Request IR-1:

Referencing pages 6 and 15 of 67, NS Power stated that Evergreen scenario CE1-E1-R2 (net zero 2035, current policy and trends for electrification, no Atlantic Loop) was used as the basis for the 2024 10-Year System Outlook report as it is the planning scenario which most closely aligned to the Province's Clean Power Plan, NS Power's The Path to 2030, and the 2024 Load Forecast. It also stated, "This scenario was among the lowest cost plans evaluated which achieves the 2030 decarbonization targets and the federal target of a net-zero electricity system in 2035."

Request IR-2:

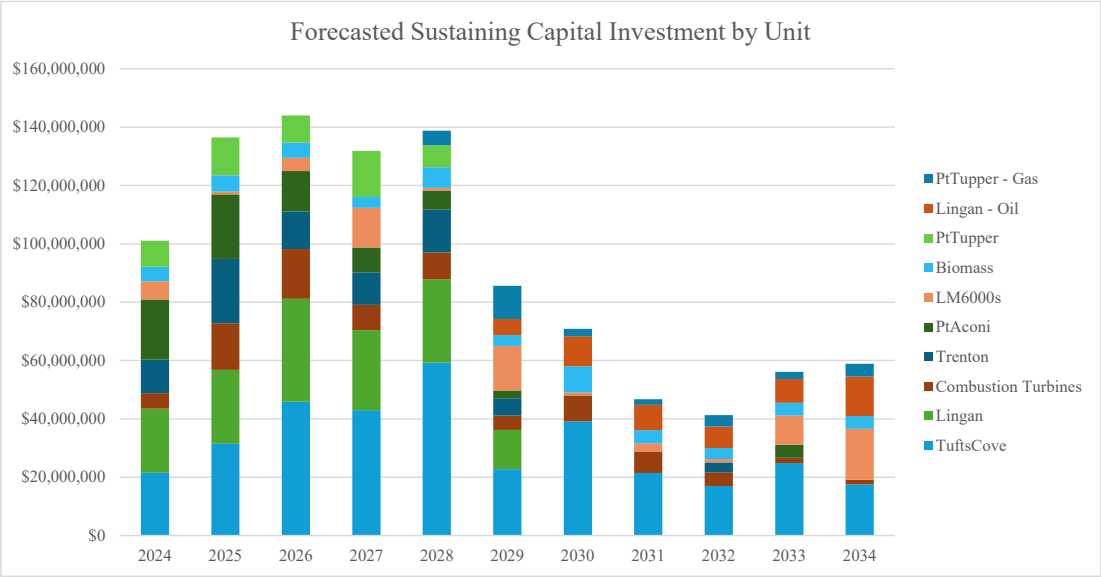
On page 28 of 67, Figure 11 presents forecasted sustaining capital investments by unit in graphical form. Please provide this investment information in a table and explain any changes from the response provided last year to Board IR-5 in Matter M11221.

Changes from the response provided in NSUARB IR-5 from M11221 include:

- The 2024 forecasted sustaining capital is now organized by plant rather than unit.
- Major investment intervals and sustaining capital cost estimates have been updated based on revised utilization forecasts and updated condition assessments.
- POT gas conversion, LIN oil conversion, and auxiliary boiler cost estimates have been updated.
- LM6000 and combustion turbine fleets have been broken out individually and forecasts updated based on utilization.
- Includes additional sustaining capital spend at PHB boiler, air heater, and precipitator based on condition and forecasted unit utilization.
- Lingan 2 retirement moved from Winter 2025/26 to Winter 2027/28 resulting in additional sustaining capital costs.
